**URGENT FIELD SAFETY NOTICE**

**REPLY FORM**  
**QIL FY25-EMEA-15-FY25-038 CCD Color Performance Test Failure**

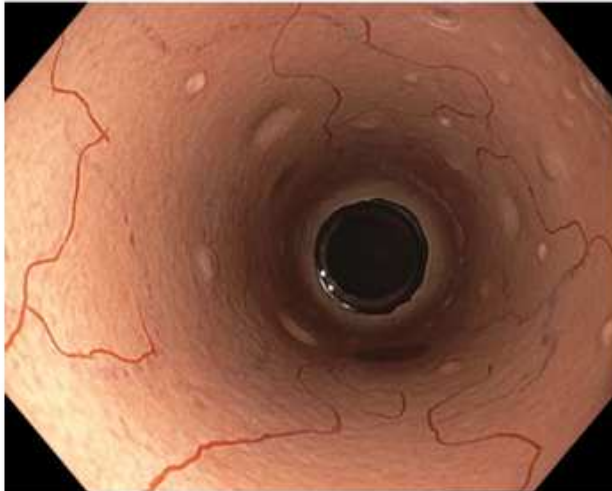
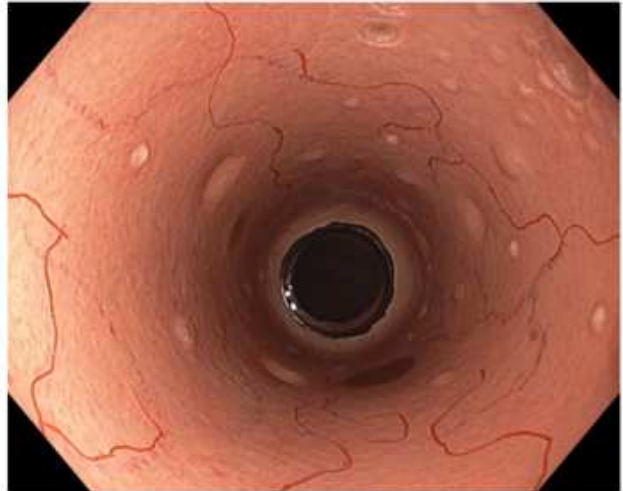
It was discovered during device performance testing that the CCD imaging sensors were programmed with the incorrect color correction data and therefore, specifications are not met. The overall effect on the device is a slightly less intense or faded representation when compared to the desired color, and in addition the color blue is slightly shifted to a more purple shade. See images below.

Incorrect color correction data

Correct color correction data

Incorrect color correction data

Correct color correction data

1. Carefully read the content of this notification.
2. Examine your inventory and identify the above-listed device with the affected serial number.
3. Olympus representative will reach out to you to arrange a mutually convenient time for the return of your device to an Olympus Repair Center to receive a color adjustment.
4. If you have further distributed this product, identify your customers, and forward them this notification.
5. Olympus requests that you acknowledge receipt of this letter. Indicate on the Reply Form that you have received and understood this notification by filling out and returning the completed enclosed Reply Form back to your local Olympus representative **XXX** latest by **XXX**.
